**Re: TLC Pet and Uptown Cat Hospital
1300 Wyoming Blvd NE
Request Permanent C.O. - Accepted
Engineer's Stamp dated: 10-29-14 (J20D027)
Certification dated: 5-27-15**

**Re: TLC Pet and Uptown Cat Hospitals, 1300 Wyoming Boulevard, N.E.
Traffic Circulation Layout
Engineer's/Architect's Stamp dated 10-06-14 (J20-D027)**

**Re: TLC Pet and Uptown Cat Hospitals
1300 Wyoming Boulevard, N.E.
Request for Traffic Circulation Layout (TCL) for Building Permit Approval**

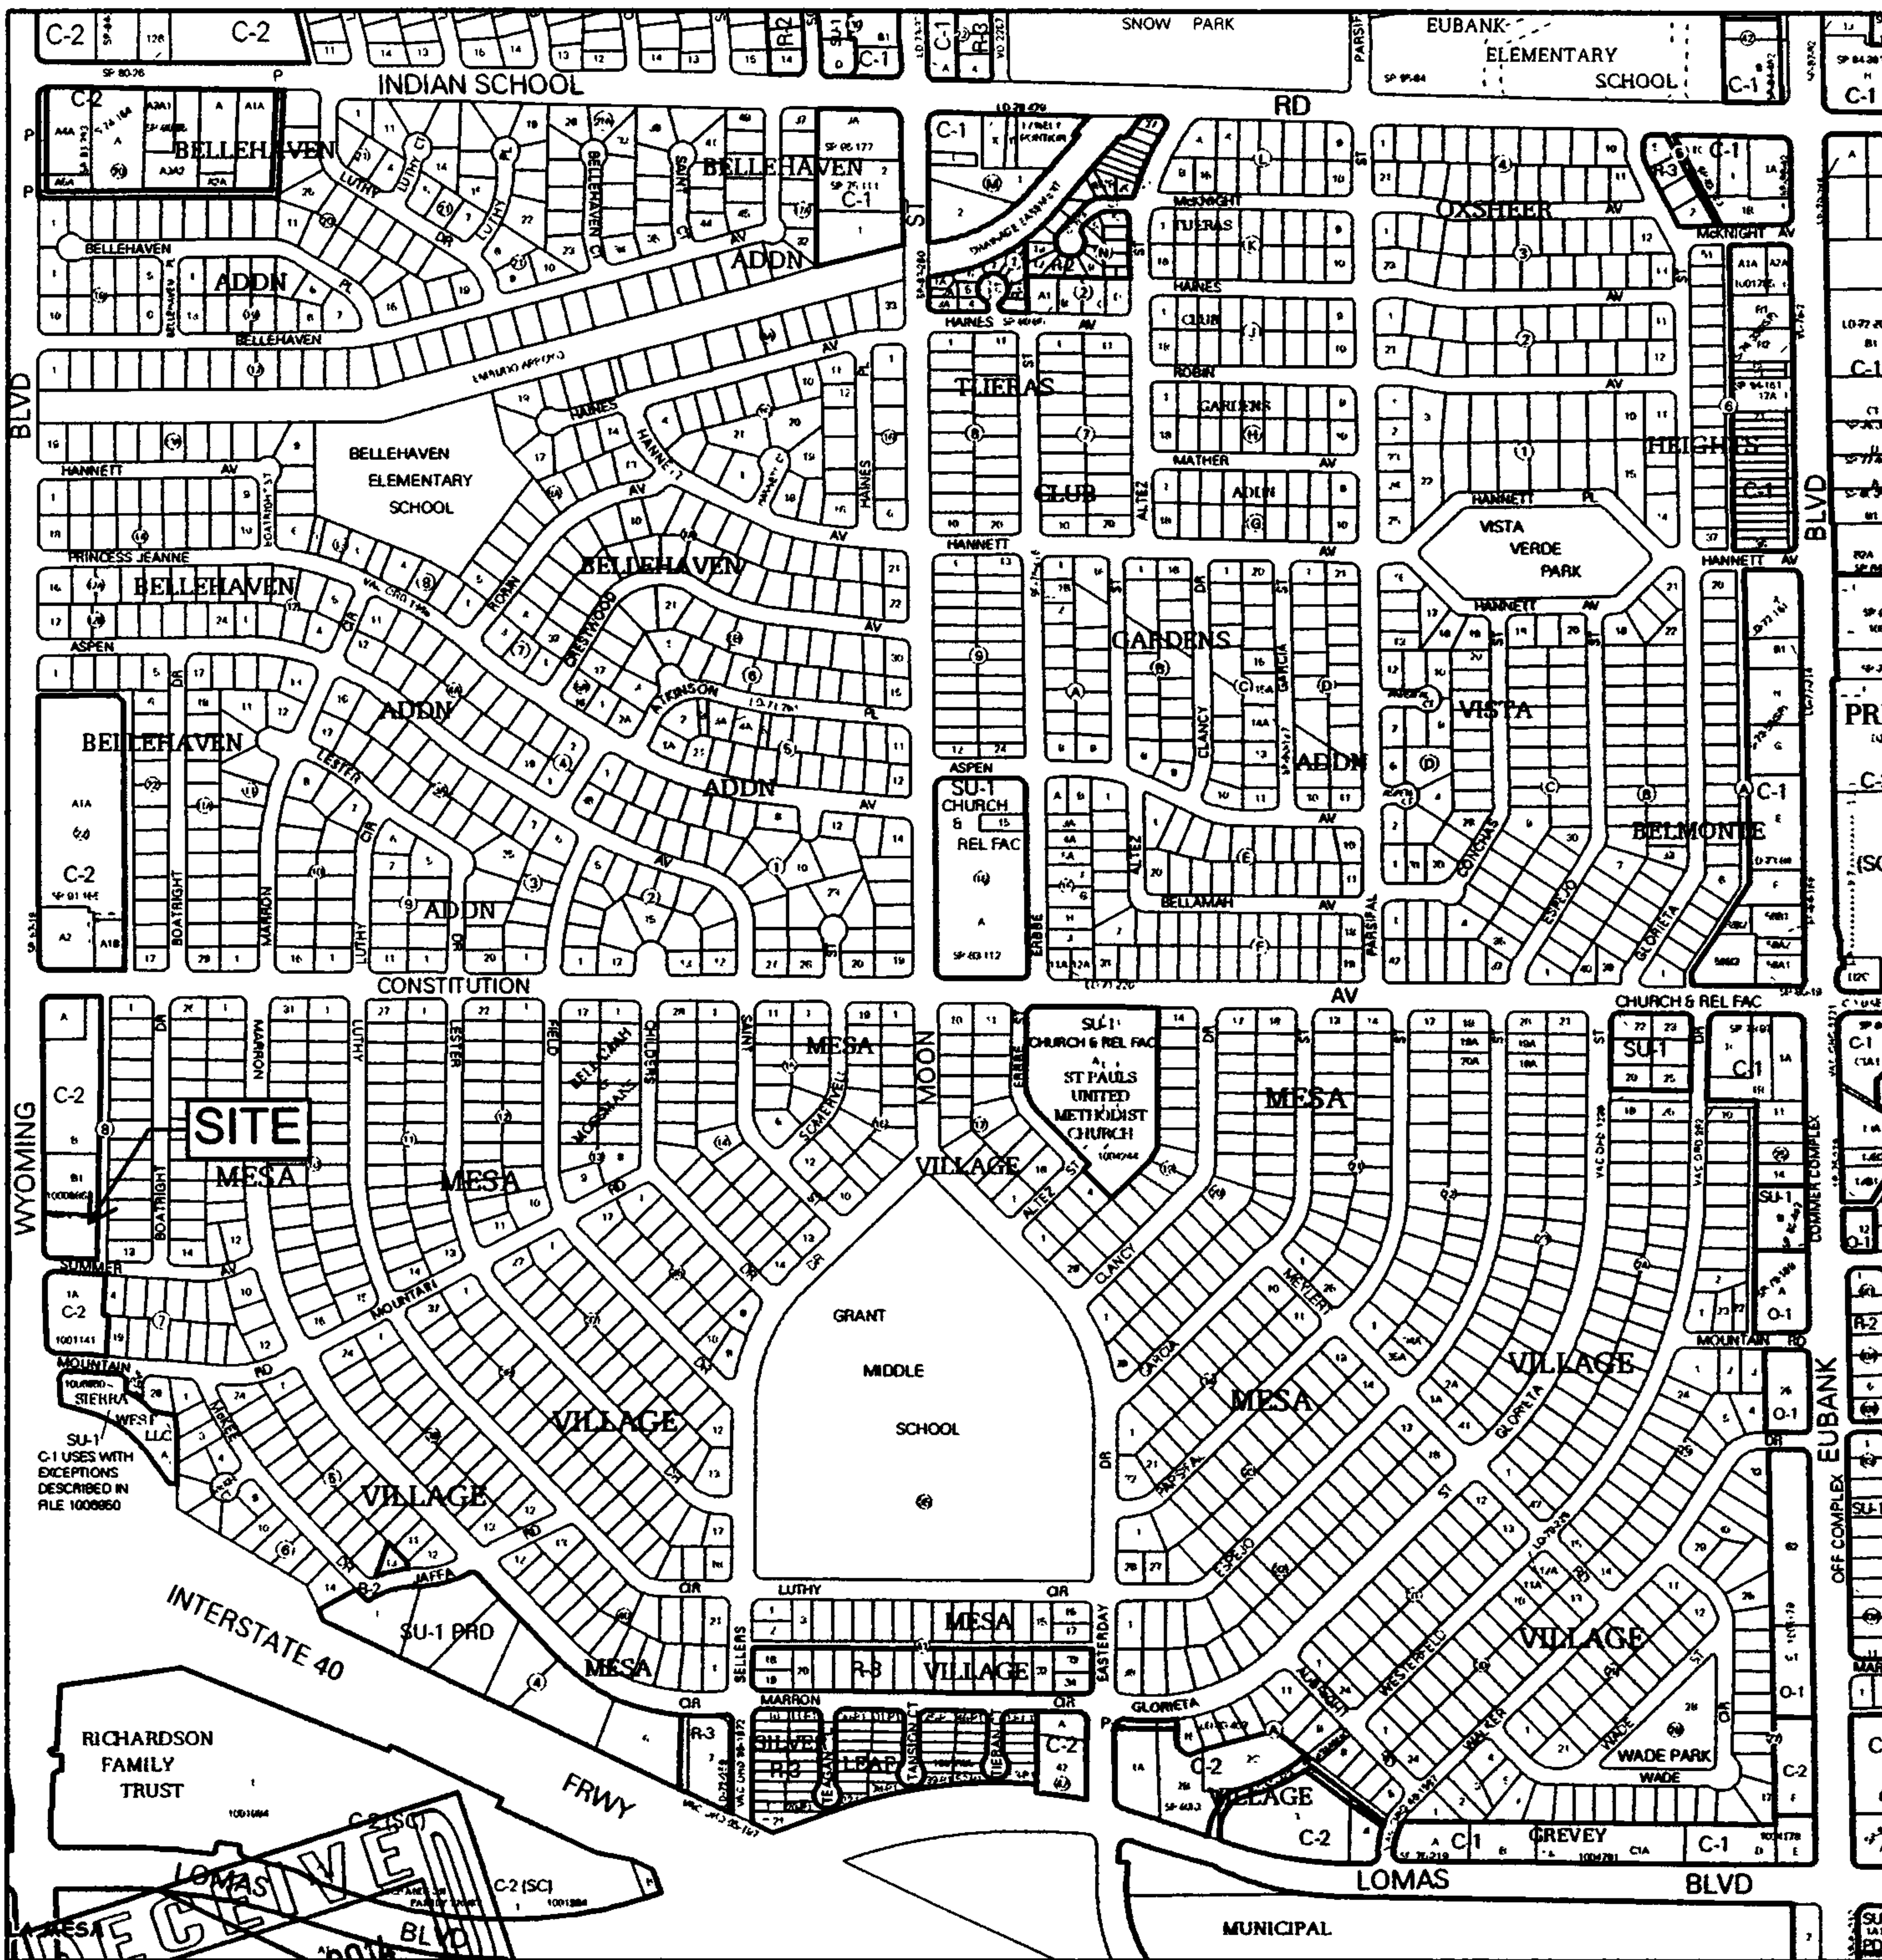
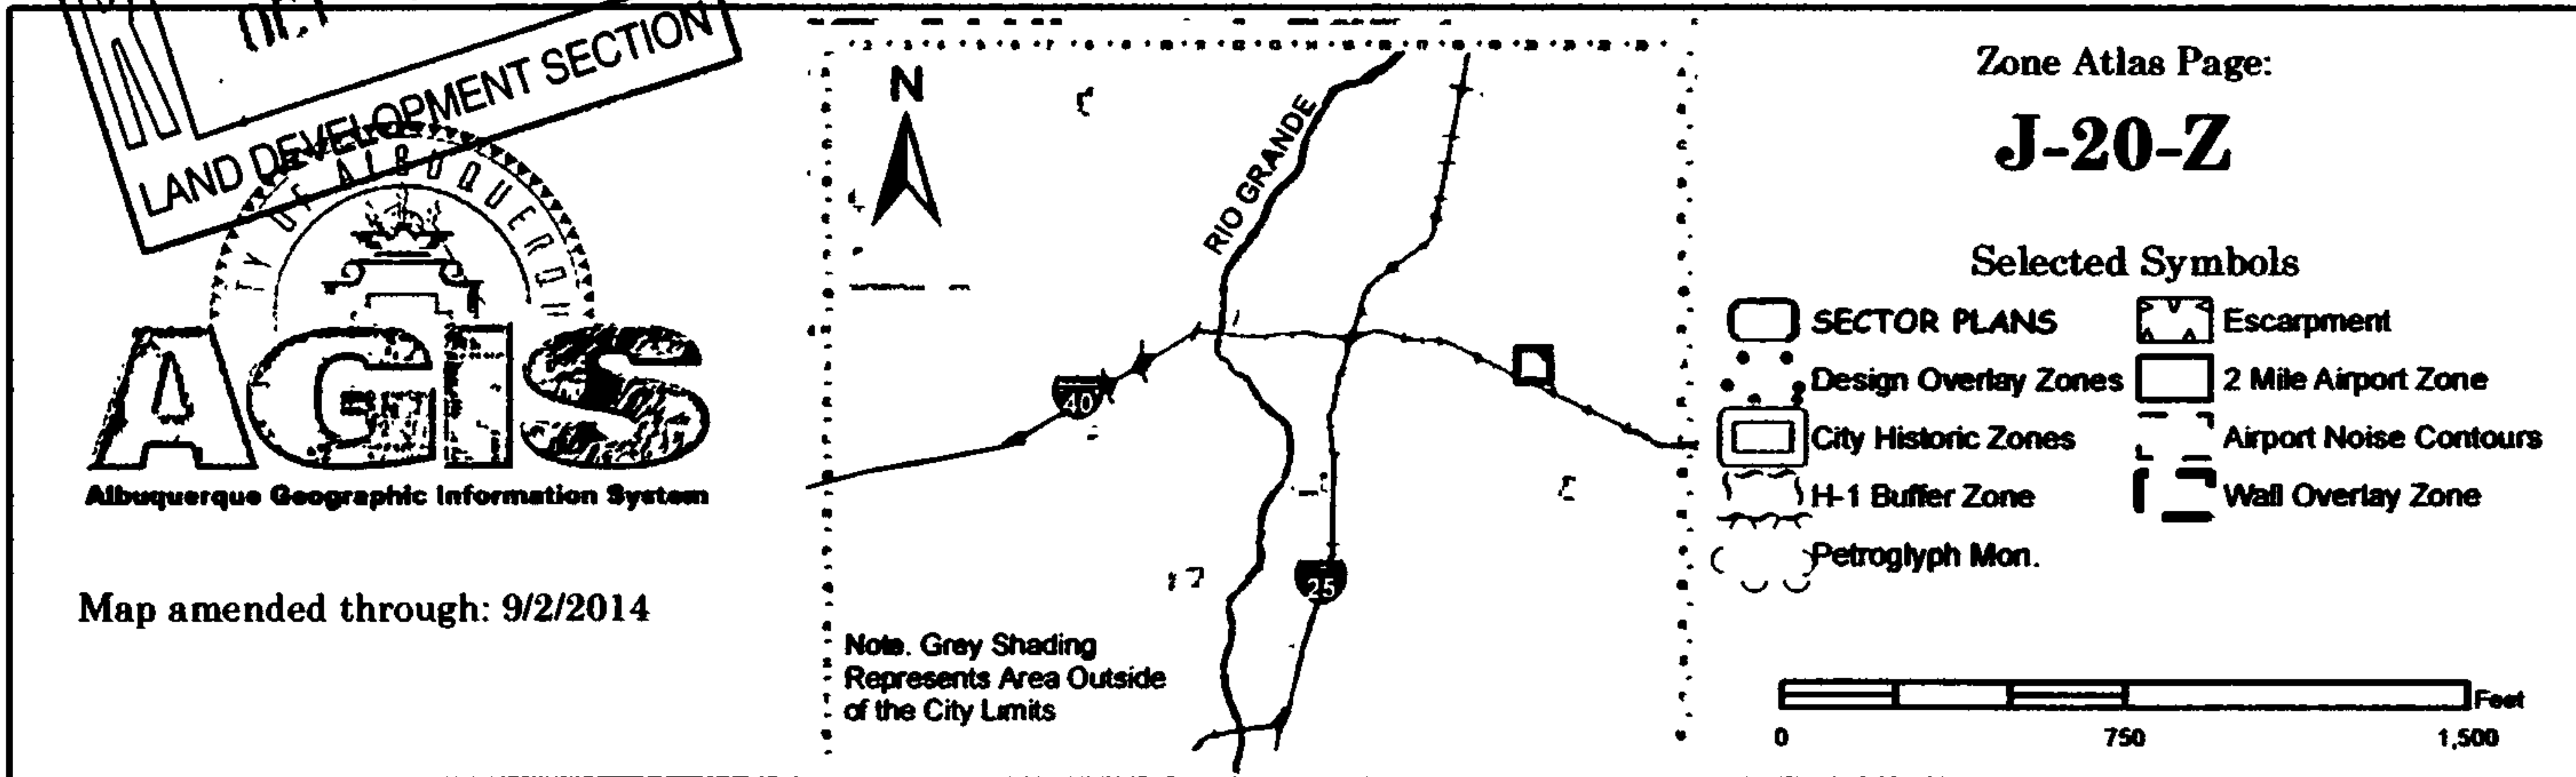
Based upon the information provided in your submittal received 10-07-14, the above referenced plan cannot be approved for Building Permit until the following comments are addressed:

1. Please provide a vicinity map with the location of the site development in relation to surrounding streets.
2. Please provide a legend for the various line-types and hatching.

3. Identify the existing right-of-way width, medians, and street widths for Wyoming Boulevard and Summer Avenue.
4. In addition to being too close to the Summer Avenue intersection, the existing drivepad on Wyoming Boulevard does not match up with the driving aisle. Revise the existing drivepad to match up with the driving aisle along the south side of the access.

5. On the southwest corner of the parking lot, make a correction from "3 Spaces @9'-0" = 18' " to " 2 Spaces@9'-0" =18' ".
6. For Keyed Note 16, the ADA van accessible sign must have the required language per 66-7-352.4C NMSA 1978 **"Violators Are Subject to a Fine and/or Towing."**

7. The ADA access aisle shall have the words **"NO PARKING"** in capital letters, each of which shall be at least one foot high and at least two inches wide, placed at the rear of the parking space so as to be close to where an adjacent vehicle's rear tire would be placed. (66-1-4.1.B NMSA 1978)

8. See Figure 23.7.2 of the DPM for end of parking aisle islands. Change the curb radii from 1 foot to 3 feet where shown on parking aisle islands near the end of

the parking spaces. Curb radii should be 15 feet for passenger vehicle maneuvering.

9. Graphically, it appears that it will be difficult to incorporate a 6-foot wide flat ADA-accessible path in front of the door in addition to a ramp with a 12:1 slope. (Make sure that both the 12:1 ramp and a 6-foot pathway can be incorporated. The ramp is only drawn at a 5-foot length.)

10. Call out curb height for Keyed Note 12. Keyed Note 12 needs to correctly point to curb for access off of Wyoming Boulevard.
11. For ease of refuse vehicle maneuvering, move the refuse at least a few feet to the east away from the curb.

12. Indicate what pavement thickness will be used for the parking lot.
13. The proposed landscaping at the access off of Summer Avenue may interfere with the sight distance. Provide clear site triangle. (See DPM Manual Page 23-74 of the DPM for Mini Clear Site Triangles for Driveways.)

14. Please add the following note to the clear sight triangle: "Landscaping and signage will not interfere with clear sight requirements. Therefore, signs, walls, trees, and shrubbery between 3 and 8 feet tall (as measured from the gutter pan) will not be acceptable in this area."

15. Please specify the City Standard Drawing Number when applicable.
16. Work within the public right of way requires a work order with DRC approved plans.

17. Please include two copies of the traffic circulation layout at the next submittal.
